**Response to NRC Review Comments  
Transmitted by Letter Dated June 22, 2001,  
to the Nuclear Energy Institute Relating to**

***PWR Materials Reliability Program  
Interim Alloy 600 Safety Assessment for US PWR Plants (MRP-44)  
Part 2: Reactor Vessel Top Head Penetrations  
EPRI TP-1001491, Part 2, May 2001***

**MRP 2001-050NP**

**June 29, 2001**

Figure 1  
Locations of Leaking CRDM Nozzles at Ocone and ANO-1

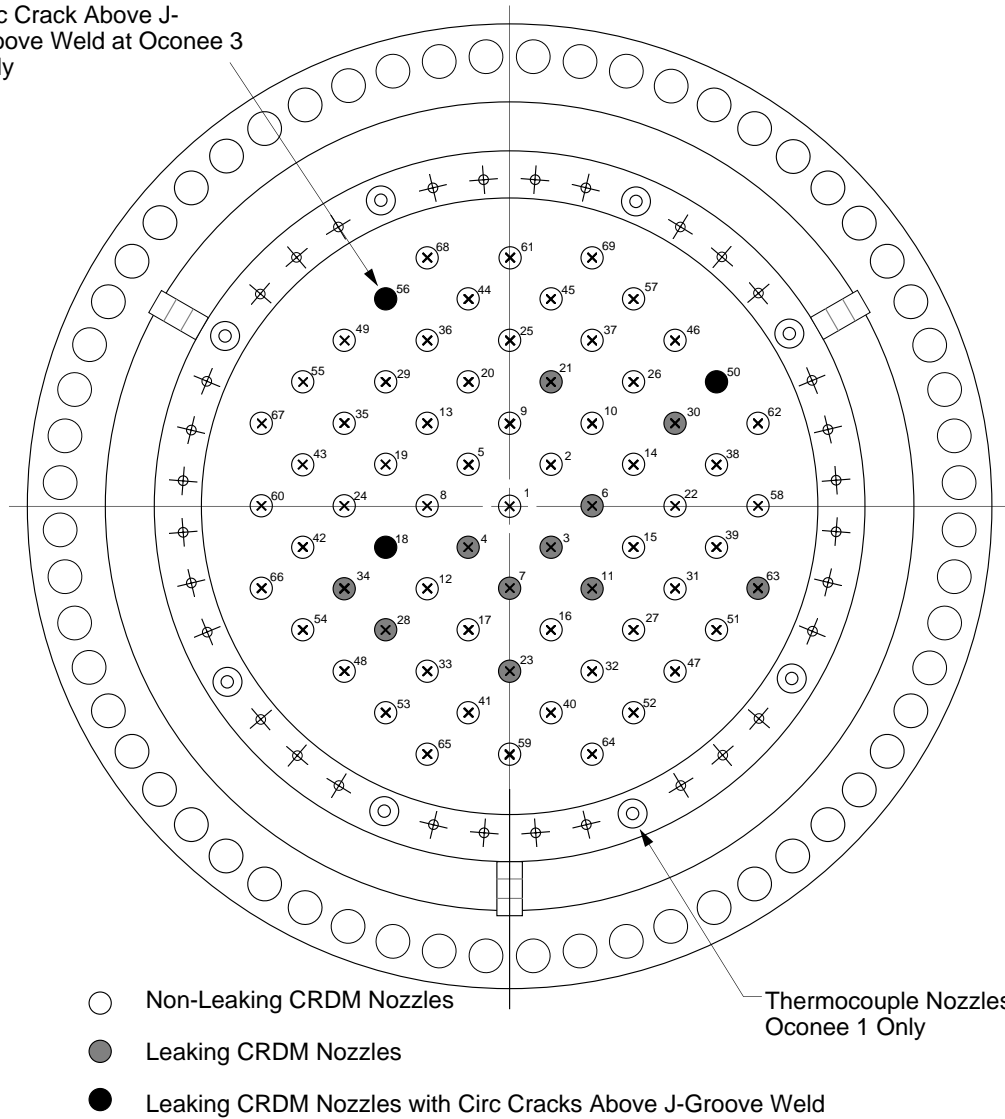
*"Appropriate consideration of the interference fit incorporated into the initial fabrication of the vessel head penetrations (VHPs) is important in evaluating the ability of visual leakage detection methods (e.g., boric acid walkdowns) to accurately identify through-wall degradation at the subject locations. While the recent instances of cracking in several VHPs at ANO-1 and Oconee Units 2 and 3 indicate that it is possible to detect through-wall flaws caused by primary water stress corrosion (PWSCC) based on boric acid walkdowns that can look under the insulation, the information provided in Section 3 of the MRP-44, Part 2 report does not support the conclusion that these events were "bounding" (i.e., that, for a similar size through-wall flaw at some other facility, an equivalent or greater amount of leakage would be expected)."*

- As shown in Figure 1, Oconee and ANO-1 experience demonstrates that leakage can be detected from nozzles adjacent to the central nozzle and in peripheral locations. This provides confidence that leakage can be detected regardless of location on the head.

Figure 3  
Actual Interference Fits of Leaking CRDM Nozzles at Oconee 1, 2 and 3 and ANO-1

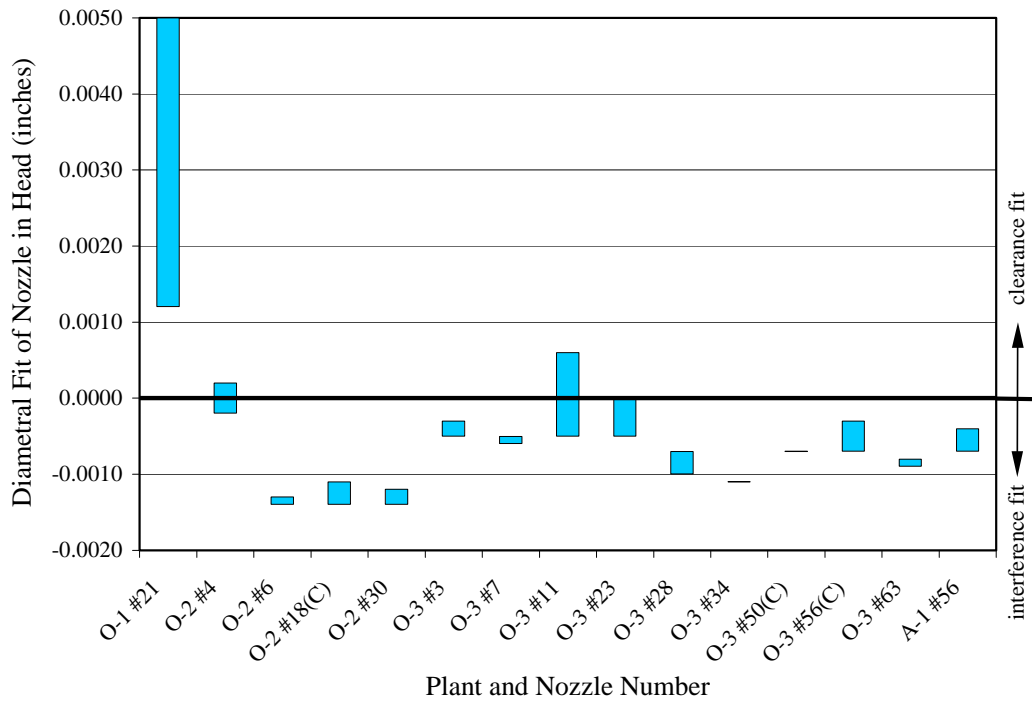
*"In order to better understand the leakage potential of PWSCC at VHP locations, and to assist in understanding how comparisons can be made to the leakage potential for VHPs at other facilities, the staff request additional information detailing the precise interference fits (as opposed to a range of values) for the VHPs which leaked at ANO-1 and Oconee."*

Figure 3 shows the range of fits for the leaking CRDM nozzles at Oconee and ANO-1. The information provided during the June 7 meeting for Oconee 1, Oconee 3 and ANO-1 has been supplemented with data for the four leaking nozzles at Oconee 2. The three nozzles found to have circumferential cracks above the J-groove weld are appended with "(C)" in the figure.

The data in Figure 3 show that one nozzle had a clearance fit rather than the specified small interference fit. The remaining nozzles had at least one end of the interference fit region within the specified tolerance. It should be noted that three of the four leaking nozzles at Oconee 2 had interference fits of 0.0014 inches at one end and at least 0.0011 inches at the other end. In summary, leaks have been confirmed from fourteen nozzles with confirmed initial interference fits, including three nozzles with at least 0.0014 inches of assembly interference.

Figure 4  
Typical FEA Model of Central CRDM Nozzle

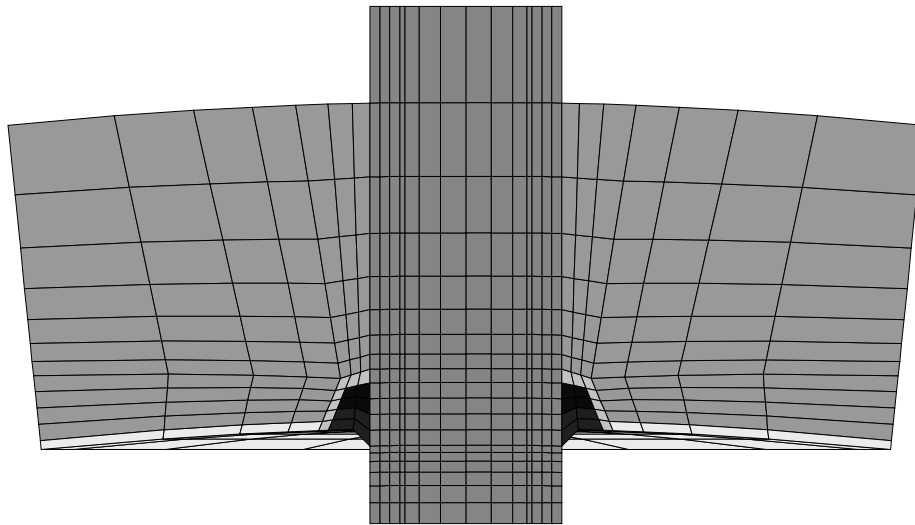
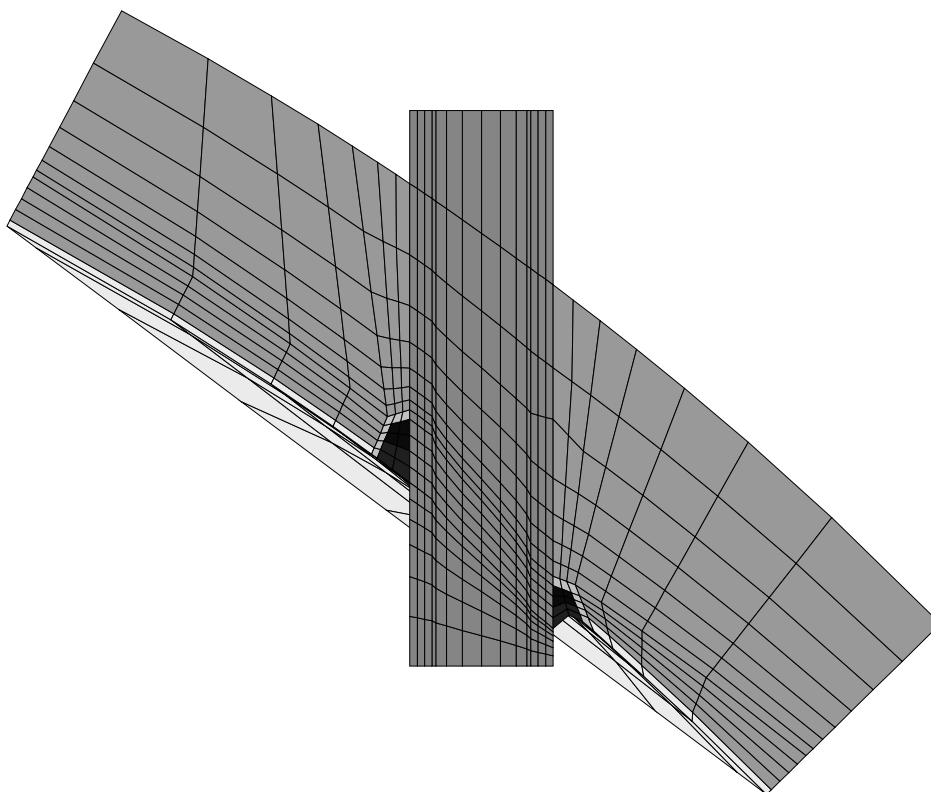
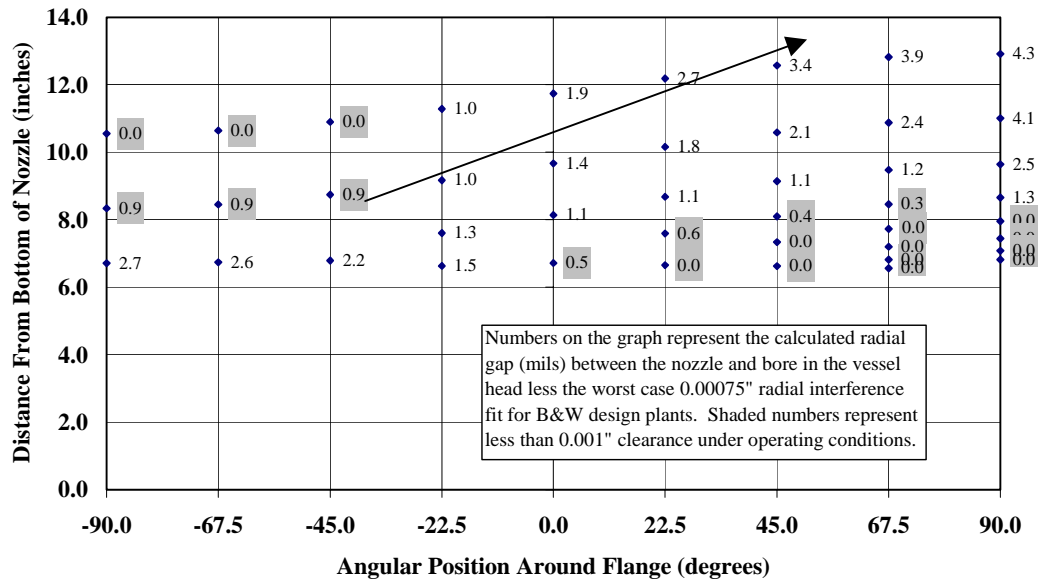
*"The staff notes that, based on information in ASME Code Section II, Part D, the coefficient of thermal expansion for Alloy 600 is slightly greater than that for low alloy vessel steels throughout the temperature range of interest (70 °F to 600 °F). This would lead to the conclusion that the magnitude of the interference fit would grow as the vessel was heated up from room temperature to operating temperature. Further, internal pressurization of the VHP nozzle may be expected to further expand the nozzle into the vessel head penetration. Other potential effects related to RPV head distortion at pressure, flange rotation, and/or vessel head penetration ovalization are not discussed in Section 3.0. Address how these factors may affect central and peripheral VHPs differently. Provide additional information to support your statement that "...analyses show that the initial fit tends to open up at operating temperature and pressure." Provide details on the finite element analysis (FEA) of the RPV head used to support this statement, including modeling assumptions, boundary conditions and results."*

Second order effects such as deflection and ovalization of oblique nozzles under pressure loading are assessed by finite element modeling of the nozzle and vessel head. Each of the NSSS vendors and EPRI has models of reactor vessel top head nozzles. Figures 4 and 5 show typical models of central and peripheral row CRDM nozzles and the associated J-groove welds. The models shown include the nozzle, a sector of the vessel shell, J-groove weld, J-groove weld buttering, and vessel cladding. Boundary conditions are imposed on the sector of the vessel shell to simulate the nozzle being installed in a complete spherical shell, and to model the initial

Finite element analyses show that oblique CRDM nozzles displace laterally if a clearance opens up between the nozzle and bore under operating conditions. The resultant displacement reduces the leak path at some locations and increases the leak path at other locations. Typical analysis results for a peripheral CRDM nozzle are shown in Figure 6. The net effect shown in this figure is to open up a spiral leak path which has less flow resistance than a uniform annular gap.

Finite element analyses of a model including the nozzle, vessel shell, and flange show that flange tensioning and resultant rotation increase the ovality of peripheral row CRDM nozzles by approximately 20%. This effect is small and, as noted in the previous paragraph, should decrease the flow resistance.

The effect of ovalization in oblique nozzles and flange rotation are primarily to change the shape of the leak path from annular to a spiral leak path. This has the beneficial effect of decreasing the flow resistance.

Figure 15  
Stress Analyses of Peripheral CRDM nozzle in Intact (a) and Cracked (b) Configurations

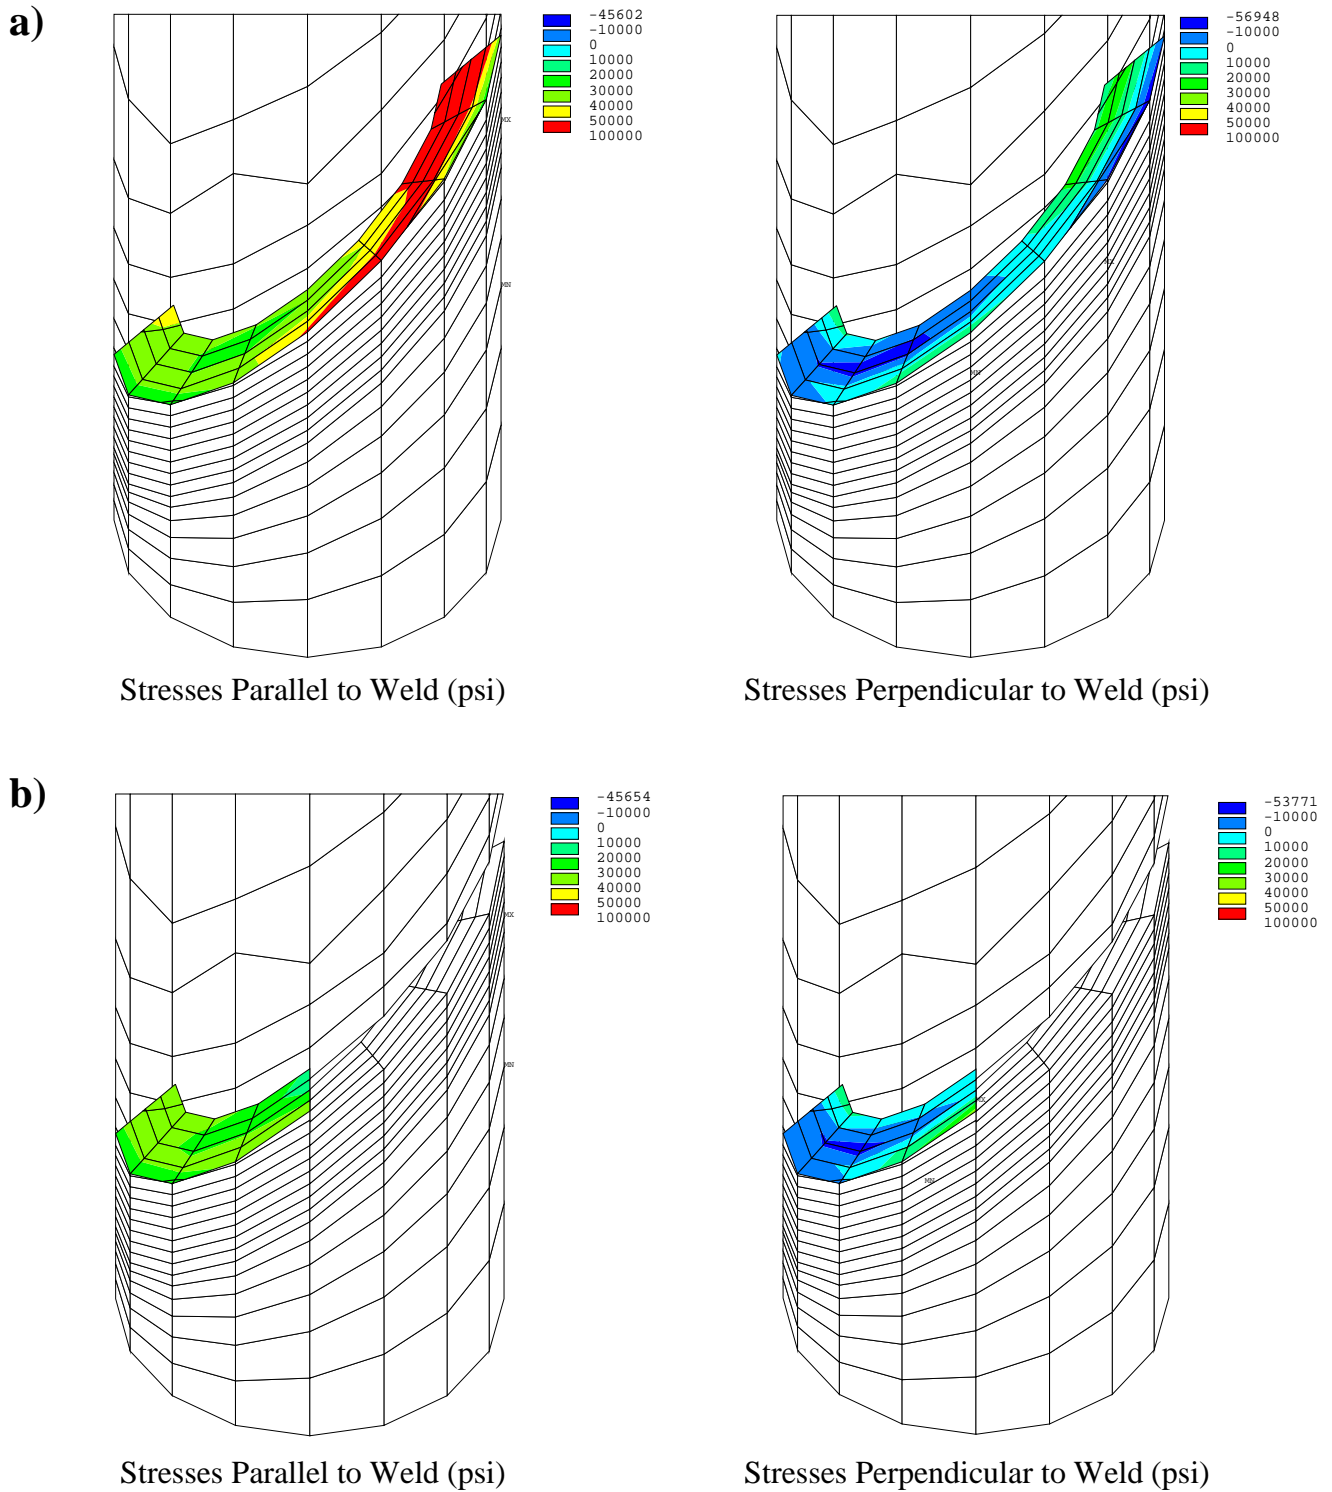
*"At a public meeting on June 7, 2001, at NRC headquarters, the industry representatives described finite element analyses (FEA) for circumferential cracks in peripheral CRDM nozzles. Provide details of the FEA modeling assumptions (such as symmetry, boundary conditions and residual stresses), the resultant stresses, and the applied stress intensity factors. How do these parameters change (e.g., stress redistribution) with crack growth in the nozzles?"*

Finite element models of CRDM nozzles have been developed by each of the NSSS vendors and EPRI. Typical models are described under the response to Section 3.0 Comment 3 and in previous submittals to the NRC in 1993-94. Typical models for central and peripheral row nozzles shown in Figures 4 and 5 have 180° symmetry and boundary conditions imposed on the sectors of the head shell to simulate an infinite shell. The J-groove welds in these models were simulated by combined thermal and structural analyses. A transient thermal analysis was used to generate nodal temperature distributions throughout the welding process. These nodal temperatures were then used as inputs to structural analyses which calculated resultant thermally-induced residual stresses as the welds cooled and gained strength. The sequence of thermal analysis followed by structural analysis was duplicated for each simulated weld pass.

Analysis results were presented at the June 7 meeting showing stresses parallel to and perpendicular to the J-groove weld for a peripheral nozzle in the intact operating condition, including the effects of welding residual stresses and hydrostatic testing prior to operation, and with the weld cracked 180° around on the uphill side of the nozzle at the elevation of the weld root. These results are repeated in Figure 15, which also shows the values for the stress contours. These data show that stresses are significantly reduced after cracking has removed some of the constraint that caused high welding residual stresses.

The model shown in Figures 4, 5 and 15 was not used to calculate crack tip stress intensity factors directly. Stress intensity factor calculations are currently being sponsored by the MRP using the finite element analysis results as inputs. Until such time as the finite element based stress intensity calculations are completed, calculations of crack growth have been performed using more traditional models such as described under Section 5.0 Comment 1.
